SITE PLAN
SCALE 1"=10'-0"
6304 LAKEVIEW DR. NE
KIRKLAND, WA 98033
PARCEL #082505-9195
ZONING: RM 3.6

HARLEY AND RITA LANG
6304 LAKEVIEW DR. NE
KIRKLAND, WA

From: Hugh Mortensen <HMortensen@watershedco.com>
Sent: Friday, September 17, 2021 2:07 PM
To: Jennifer Anderer
Cc: Nell Lund
Subject: RE: TWC 170622.45 / BSF19-01341 - As-Built Review and Monitoring and Maintenance Quotes

From: Adam Weinstein
Sent: Wednesday, December 1, 2021 5:18 PM
To: Peter Ojala
Cc: Stephanie Croll; Jennifer Anderer
Subject: Lang Permit (BSF19-01341)
Attachments: Recording Document Examples.pdf

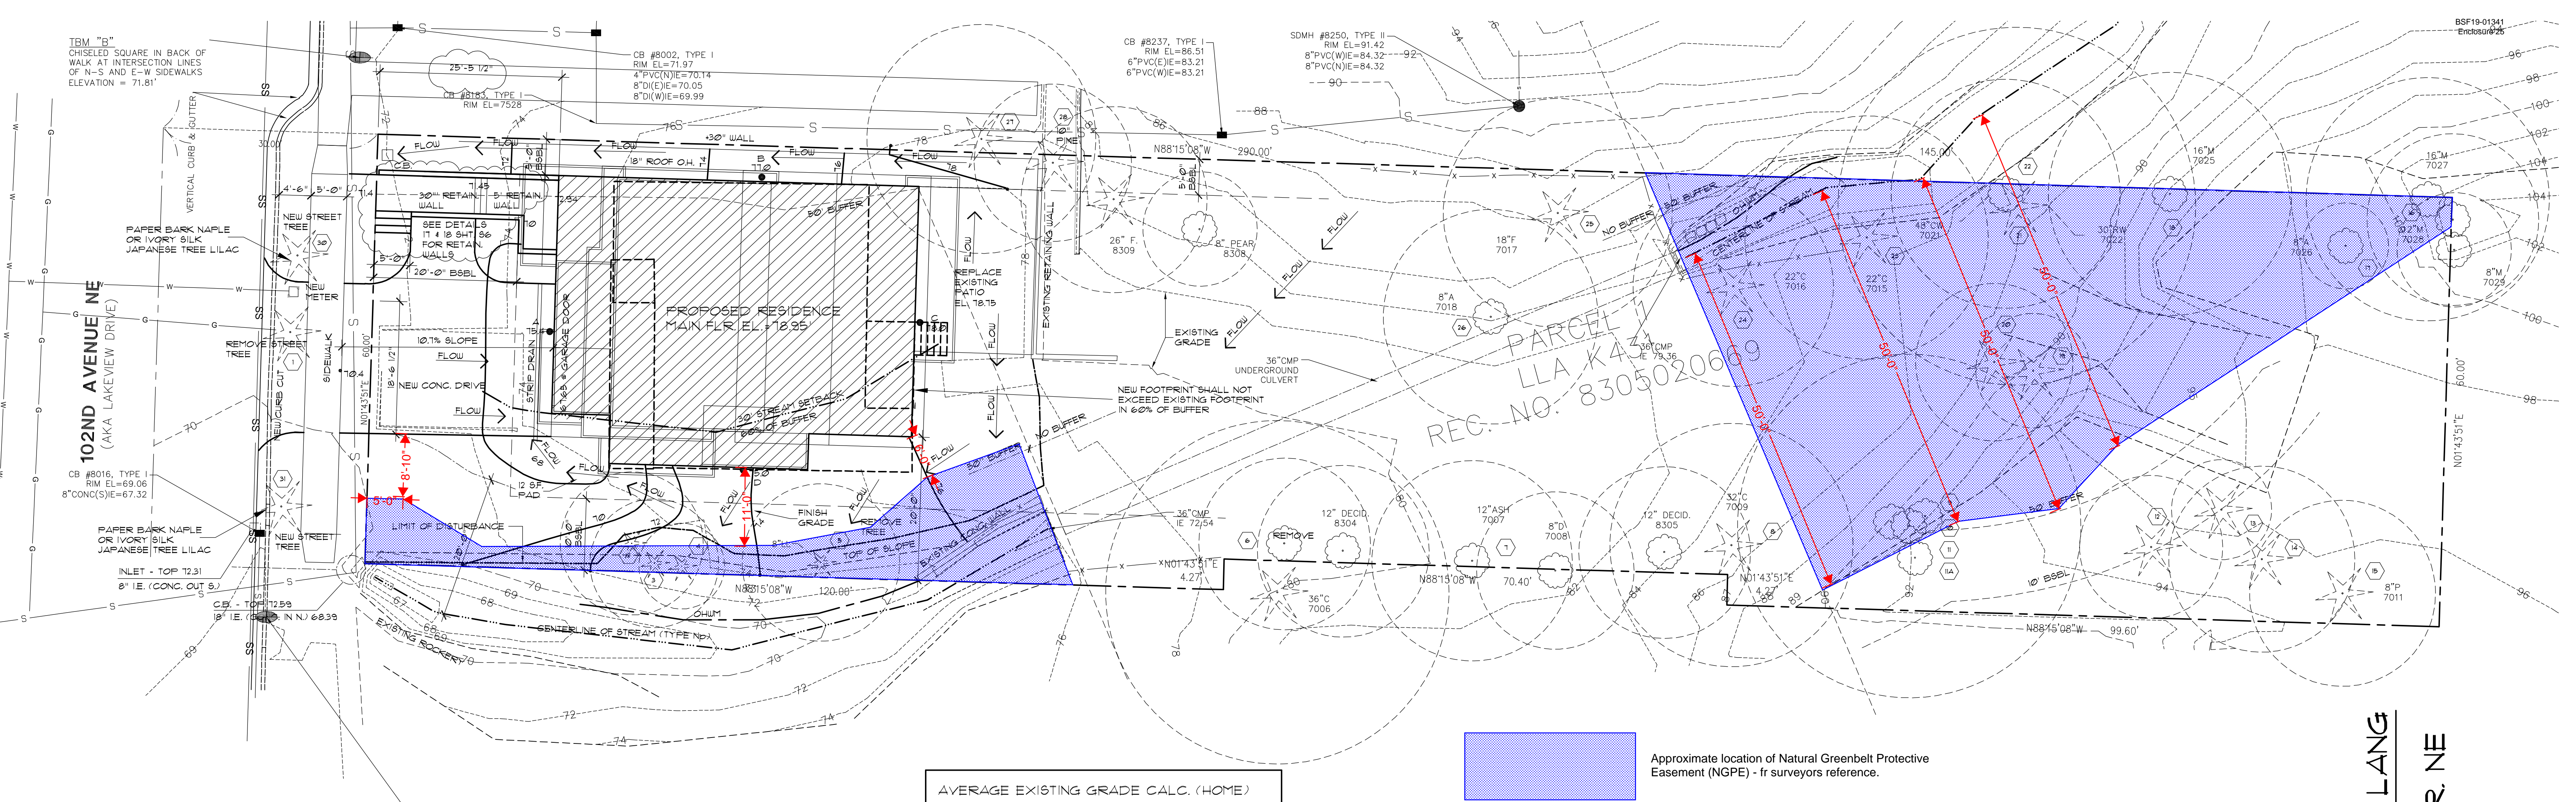
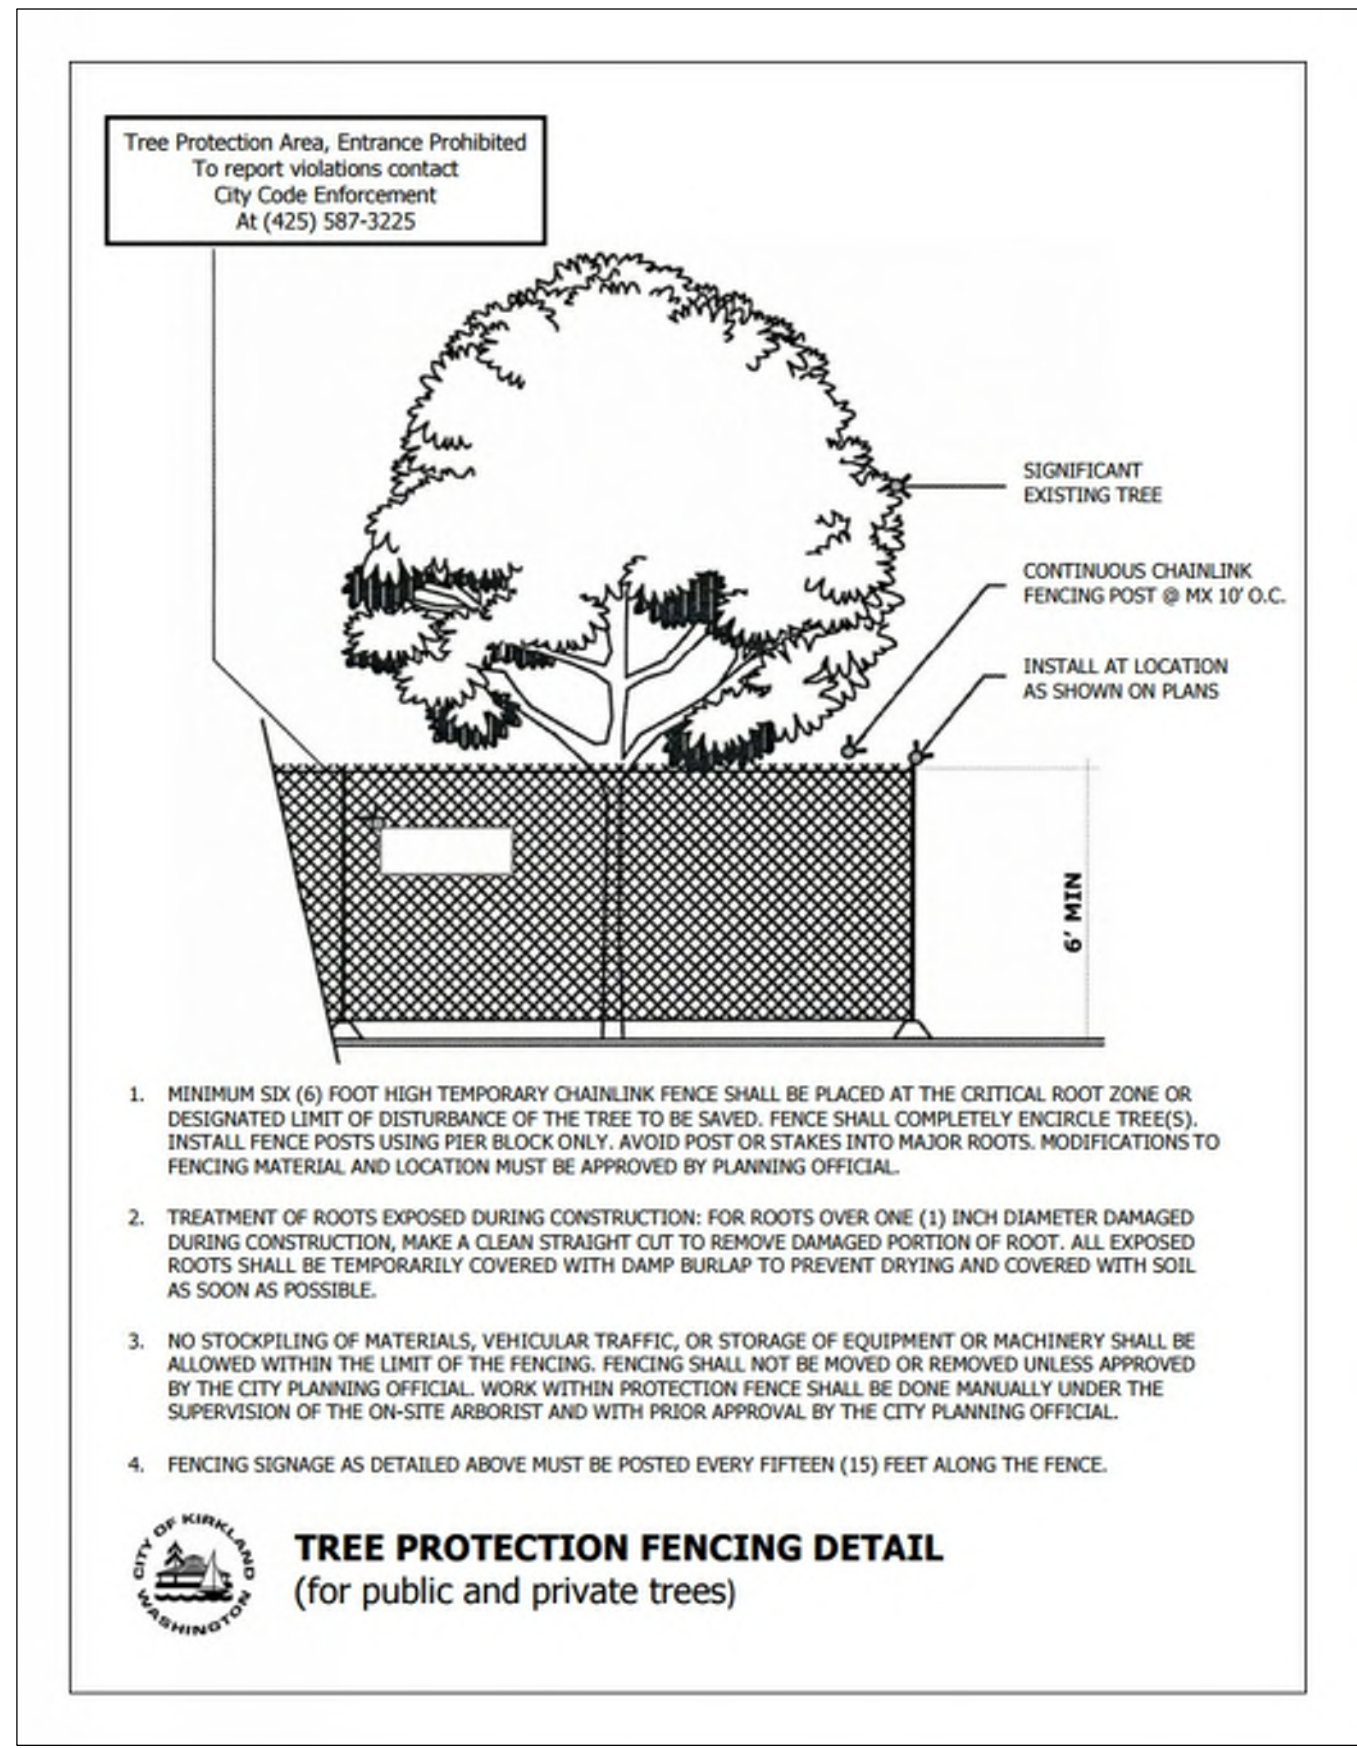
I thought this would be helpful for your surveyor's reference, attached is a marked up site plan showing the extent of the NGPE boundaries (in hatched blue) as they relate to the stream. You'll want your surveyor to create an exhibit showing the boundaries of the NGPE for the recording document (OCD 16). Your split rail fencing (as required by [KZC 90.190](#) and included in your Stream Buffer Modification and Mitigation Plan prepared by Cedarock Consultants dated November 13, 2019) should line the boundary of the NGPE. If the boundaries changed at all in the field or your surveyor identifies alternatives to the attached marked up plan please let me know and we can work together to adjust the NGPE boundaries.

Approximate location of Natural Greenbelt Protective Easement (NGPE) - fr surveyors reference.
